KIMBERLYN DOWNS ESTATES SUBDIVISION

APPLICATION NUMBER 3 DATE October 6, 2022

REQUEST Subdivision

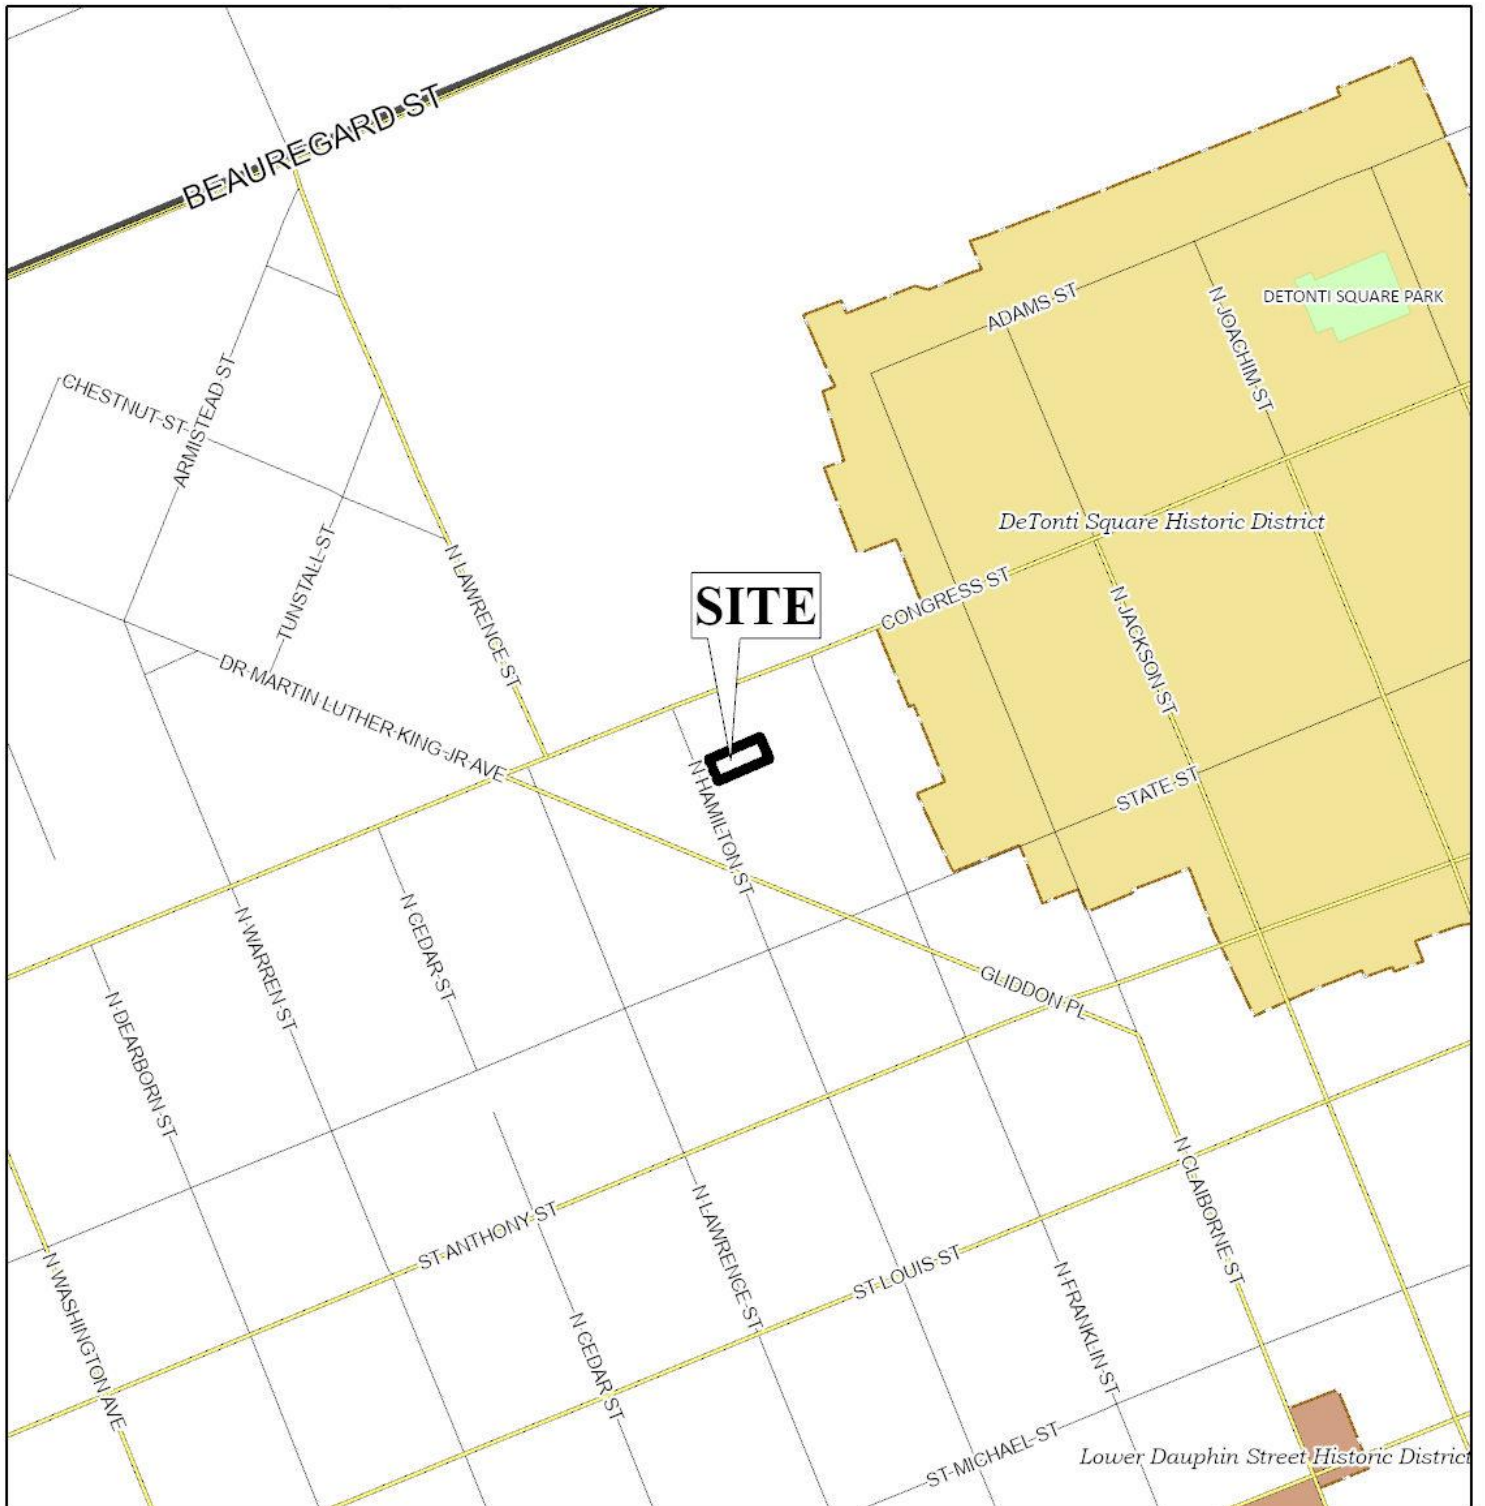
The proposed lot fronts North Hamilton Street, which is a minor street with curb and gutter and with a compliant 50-foot right-of-way; therefore, no dedication would be required along the street frontage. The right-of-way width of North Hamilton Street should be retained on the Final Plat, if approved.

The minimum lot width requirement in a T-5.1 Sub-District is 14 feet, and the maximum lot width allowed is 180 feet. The proposed lot falls within the allowable range as per the DDD requirements of the Zoning Ordinance. Although the proposed lot does not meet the minimum size requirements of Section V.D.2. of the Subdivision Regulations, as lots of a similar substandard size are common for the area. As lot complies with the DDD, a waiver of Section V.D.2. would seem in order. The preliminary plat labels the lot size in both square feet and acres

and this should be retained on the Final Plat, if approved, or a table should be furnished on the Final Plat providing this information.

Per Section 64-3.I.8.(d), in a T-5.1 Sub-District, the DDD requires twelve (12)-foot maximum setback along the primary and secondary street frontages, but the setbacks may match setbacks of adjacent buildings (along the same street frontage) where they differ from the standard. The preliminary plat shows no setback requirements. As North Hamilton Street is a “B” Street according to the Regulating Plan, Street Hierarchy and would be considered the primary frontage, a note should be required on the Final Plat, if approved, stating the setback allowances. As this differs from the standard 25-foot minimum setback required by Section V.D.9. of the Subdivision Regulations, this section will need to be waived, if approved.

As per Section 64-3.I.11.(c)(1) of the Zoning Ordinance, driveways shall be accessed from the secondary frontage, where available; however, as the proposed lot has no secondary street frontage, Section 64-3.I.11.(c)(2)ii. states that in a T-5 Sub District, a lot must be a minimum of 54 feet in width to allow frontage driveway access. As the proposed lot is 40 feet wide, a note should be required on the Final Plat stating that no driveway access is allowed, unless a variance is granted by the Board of Zoning Adjustment. If the variance is not granted, the Traffic Engineering comments would be moot in this case.

Based upon the preceding, with waivers of Sections V.D.2. and V.D.9. of the Subdivision Regulations, the plat is recommended for Tentative Approval, subject to the following conditions:

- 1) retention of the right-of-way width of North Hamilton Street on the Final Plat;
- 2) retention of the lot size label in both square feet and acres on the Final Plat, or the furnishing of a table on the Final Plat providing the same information;

- 3) placement of a note on the Final Plat stating that there is a twelve (12)-foot maximum building setback line, or the setbacks may match setbacks of adjacent buildings (along the same street frontage) where they differ from this standard;

- 4) placement of a note on the Final Plat stating that any future development of the site will require Consolidated Review Committee (CRC) approval prior to the issuance of permits;

- 5) placement of a note on the Final Plat stating that no driveway access is allowed unless a variance is granted by the Board of Zoning Adjustment;
- 6) compliance with the Engineering comments: *(FINAL PLAT COMMENTS (should be addressed prior to submitting the FINAL PLAT for review and/or signature by the City Engineer): A. Provide all of the required information on the SUBDIVISION PLAT (i.e. signature blocks, signatures, certification statements, written legal description, required notes, legend, scale, bearings and distances) that is required by the current Alabama State Board of Licensure for Professional Engineers and Land Surveyors. B. Provide reference, on the map and the description, to a monumented corner. C. Show and label the POC. D. Show and label the POB. E. Provide the information required in NOTES #3. F. Delete NOTE #14. G. Provide a written description for the subdivision*
